UNITED STATES PATENT AND TRADEMARK OFFICE

APPLICATION NO.	FILING DATE	FIRST NAMED INVENTOR	ATTORNEY DOCKET NO.	CONFIRMATION NO.
10/657,483	09/08/2003	Brian E. Curcio	END920000122US3 (IEN-10-5)	7494
26681	7590	09/11/2006	EXAMINER OLSEN, ALLAN W	
DRIGGS, HOGG & FRY CO. L.P.A. 38500 CHARDON ROAD DEPT. IEN WILLOUGHBY HILLS, OH 44094			ART UNIT 1763

Office Action Summary

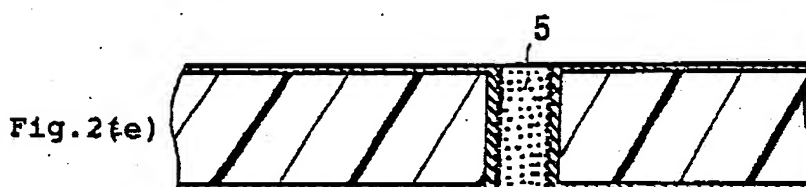
Applicant argues:

In particular, Asai et al. do not teach or suggest dispensing the conductive material in such opening, forming such nub by removing at least a portion of the conductive coating, and then electrically joining the nub with another as recited in the subject claim. Instead, Asai et al. simply disclose filling through-holes 3 with a filler 5 (Fig. 2(e) and col. 19, ll. 57-67) and then forming a film 6 over the substrate and the filled through-holes 3 (Fig. 2(f) and col. 20, ll. 1-6). Various other steps are then performed to create a printed wiring board in which the filler 5 is covered by several layers (Fig. 3(a) – Fig. 5(b)). However, Asai et al. do not teach or suggest forming a nub of filler 5 after filling the through-holes 3 by removing conductive coating from the substrate 1 and then electrically joining the nub of filler 5 with another nub. In addition, Asai et al. do not teach or suggest dispensing an electrically conductive material in such opening as recited in the subject claim. Rather, Asai et al. disclose using a screen printing, drying, and curing technique to fill the through-hole 3 with the filler 5 (Col. 20, ll. 57-61).

In response to the following statement:

" Asai et al. do not teach or suggest forming a nub of filler 5 after filling the through-holes 3 by removing conductive coating from the substrate 1 and then electrically joining the nub of filler 5 with another nub."

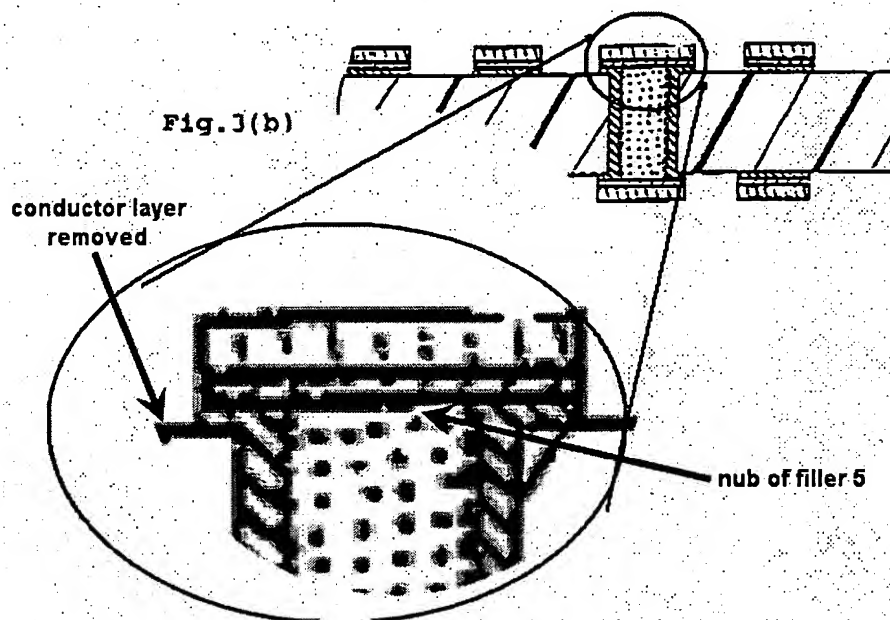
the examiner notes that figure 2(e) of Asai shows the filling of through-hole 3 with filler

5.

And, the following detail of Asai's figure 3b shows filler 5 extending above the surface of the core layer (i.e., a nub of 5) after the removal of the conductive coating 3
